ILLUSTRATED PARTS LIST LISTE DES PIÉCES

T720

**POWER TILLER
MOTOCULTEUR**

97898-40430

22. CAPOT-RESERVOIR BONNET GROUP

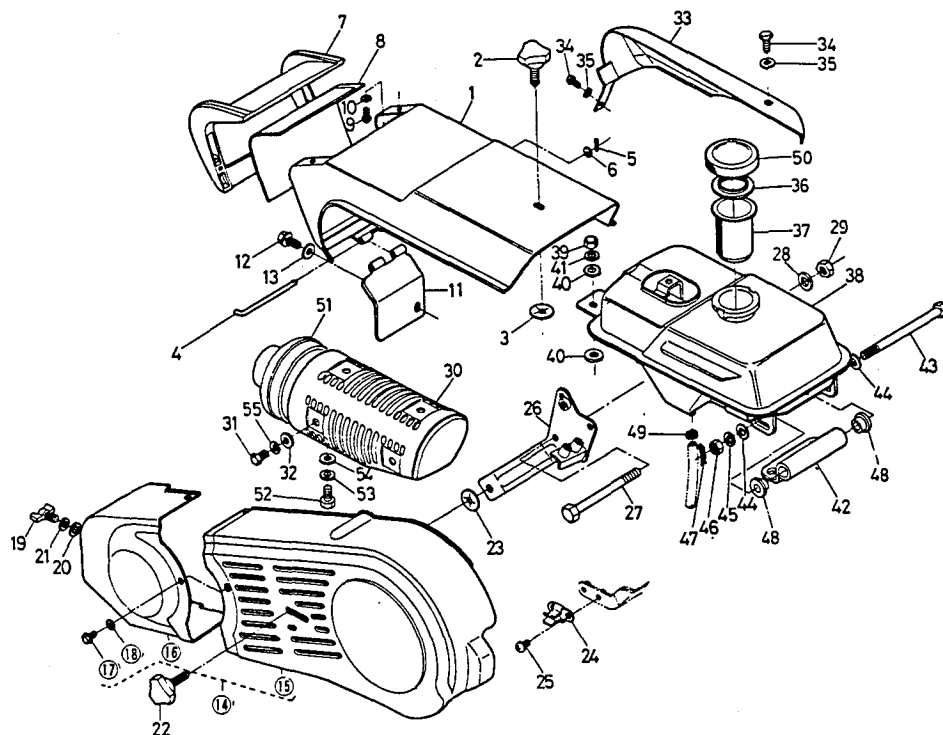
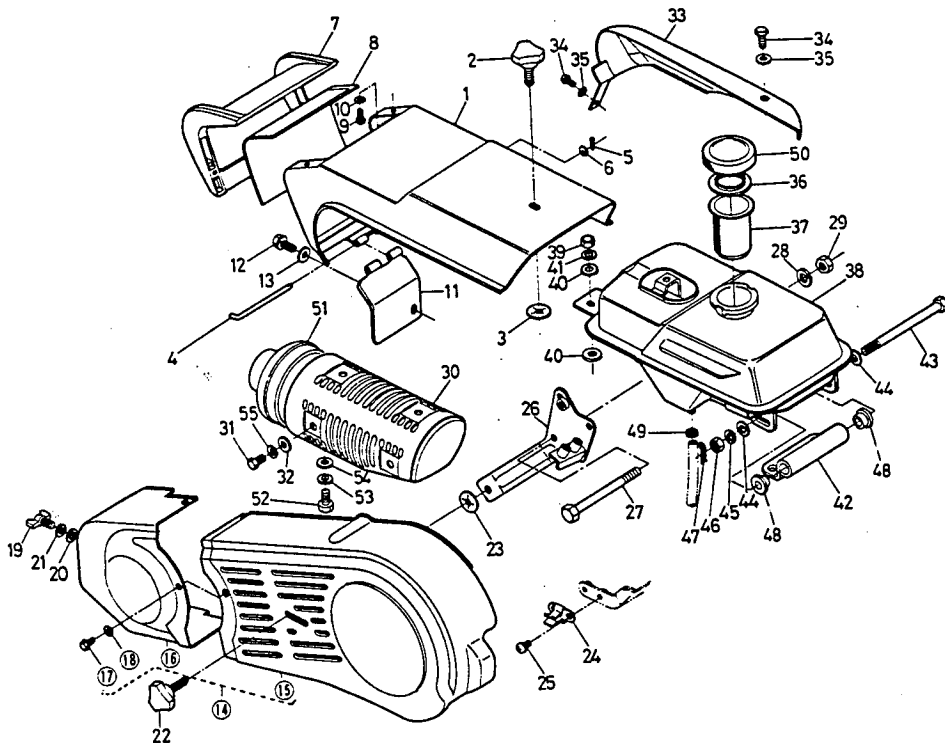
REF. No. 62271-5431-3

REF. No. 62271-5435-1

REF. No. 62271-5445-2

REF. No. 16 62271-5435-1

REF. No. 30 62271-5445-2

23. COURROIES & CARTERS PULLEY BELT GROUP

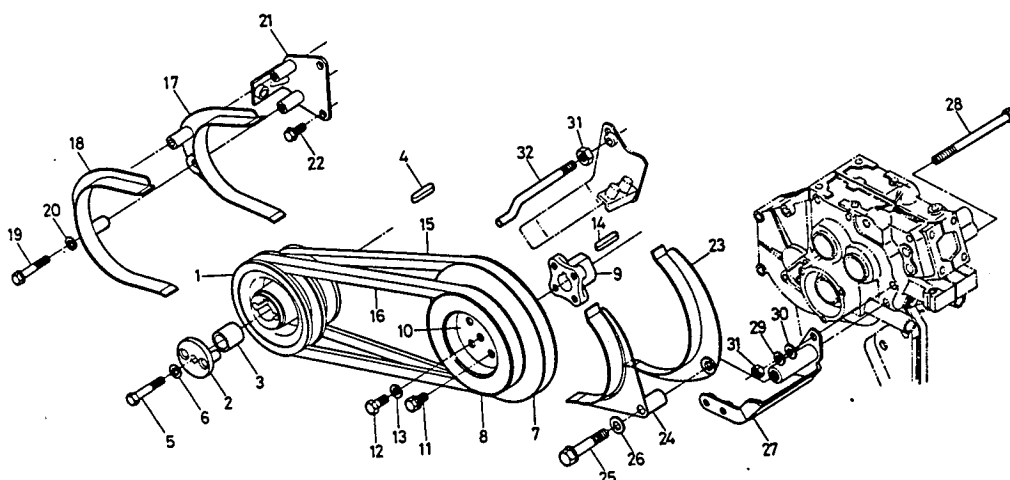
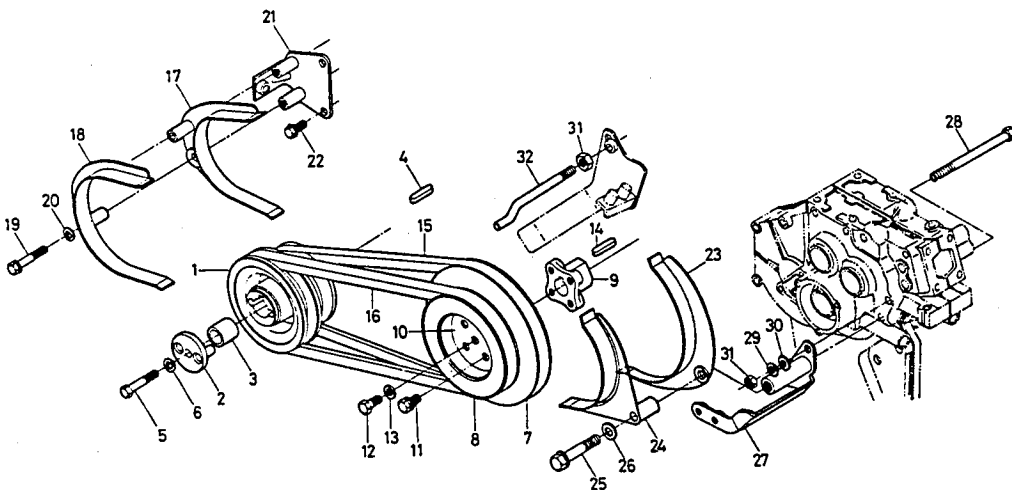
REF. No. 2 62271-6222-2

- Renforcé
- Reinforced

REF. No. 62271-6235-1

- Renforcé
- Reinforced

REF. No. 23 62271-6235-1
